**A.13-09-014 SDG&E 11/14/14 Partial Response
Salt Creek Substation Project PTC
Energy Division Request #20 on 11/3/14
ED-SDGE-020**

#	Data Request #	Request	SDG&E Response
1.	DR 16.2-1	<p>Please specify a location for the potential 230/12-kV loop-in and clarify whether or not this alternative is technically feasible.</p> <p>The response to DR 16.2, item #1 did not specify a potential location for a 230/12-kV underground loop-in. The response also indicates that an underground loop-in is likely possible and that additional engineering would be needed to confirm the feasibility. Please clarify whether or not an underground loop-in is feasible.</p>

STR. 28

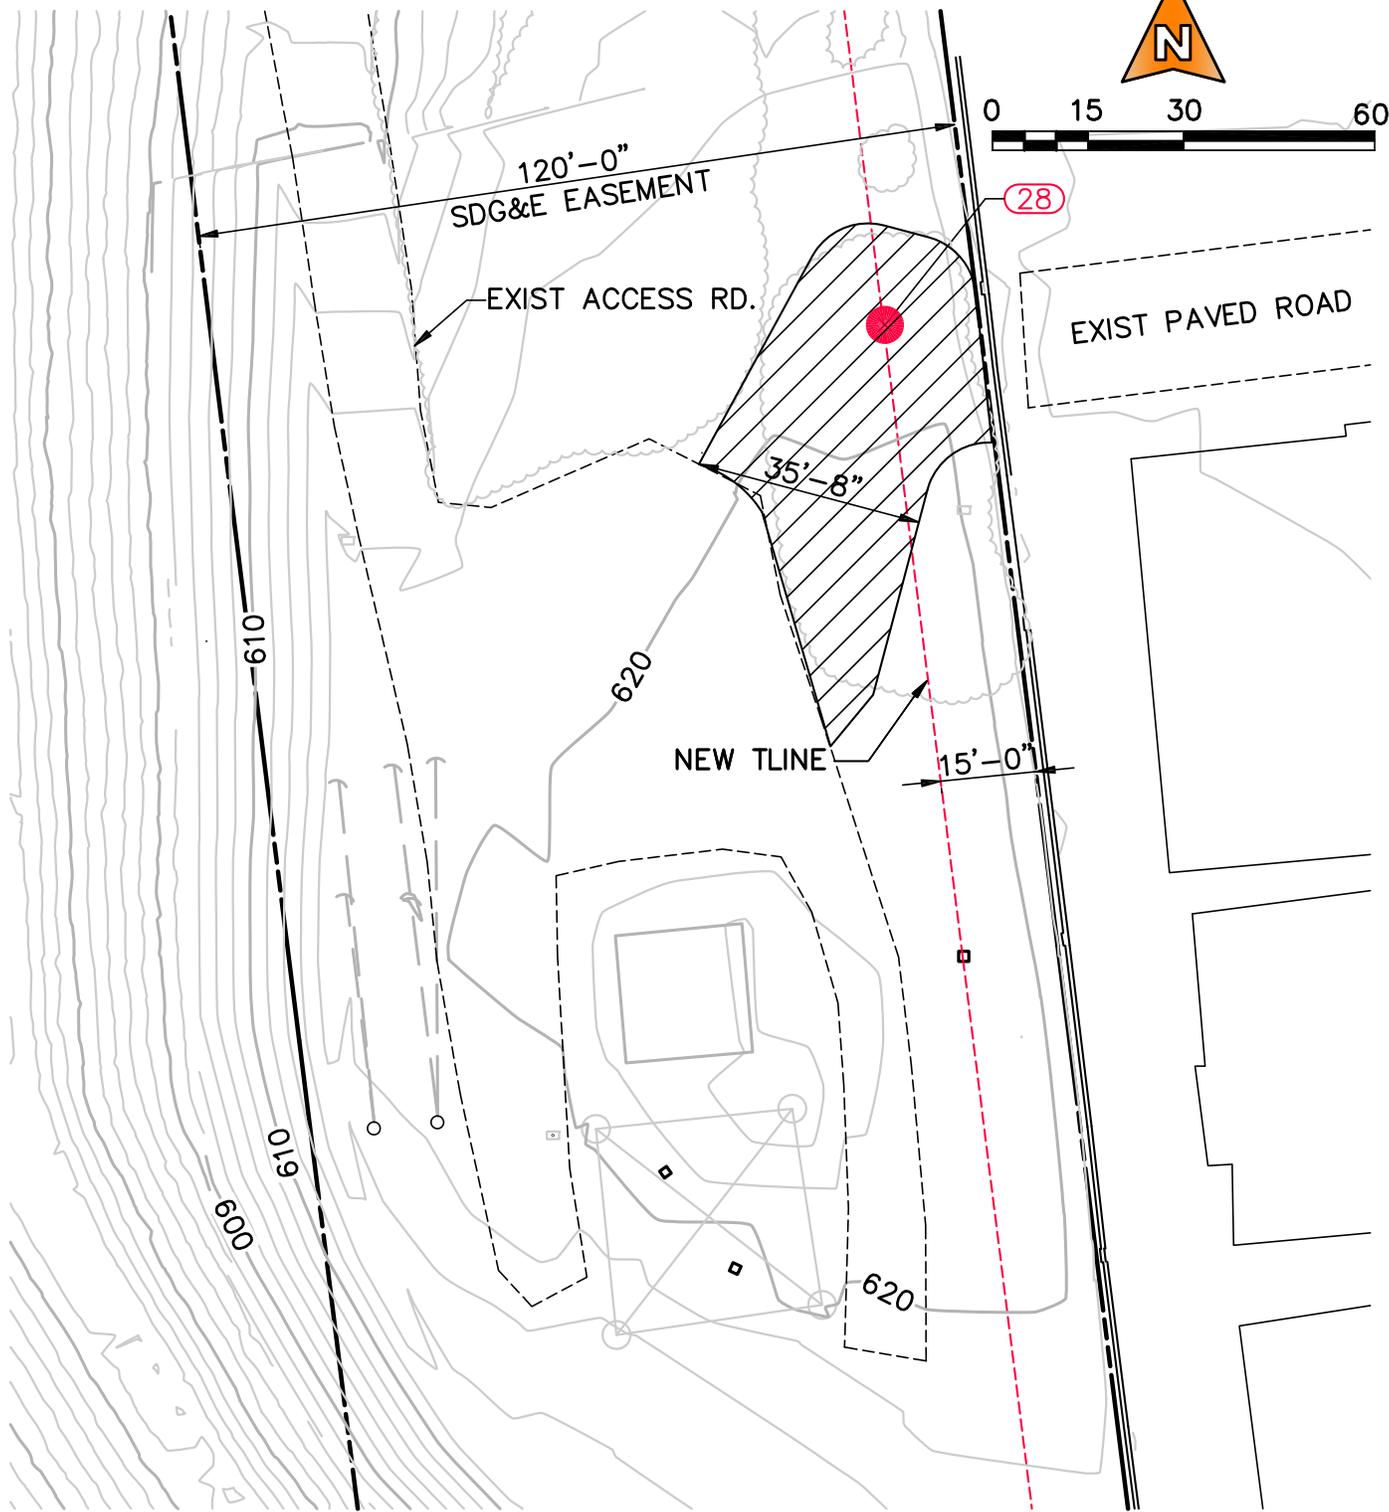
11.	DR 16.2-4	<p>Provide details on the work area and pole height for a Pole 28 relocation alternative.</p> <p>Additional details are required to analyze the pole relocation alternative in the EIR. Please provide the work area configuration and pole height for comparison with the project.</p>	<p>See attachment DR20.11-1 for estimated work area configuration. The pole height for the alternate location is anticipated to be approximately 107.5 feet above ground (105 foot pole plus a 2.5 foot reveal).</p>
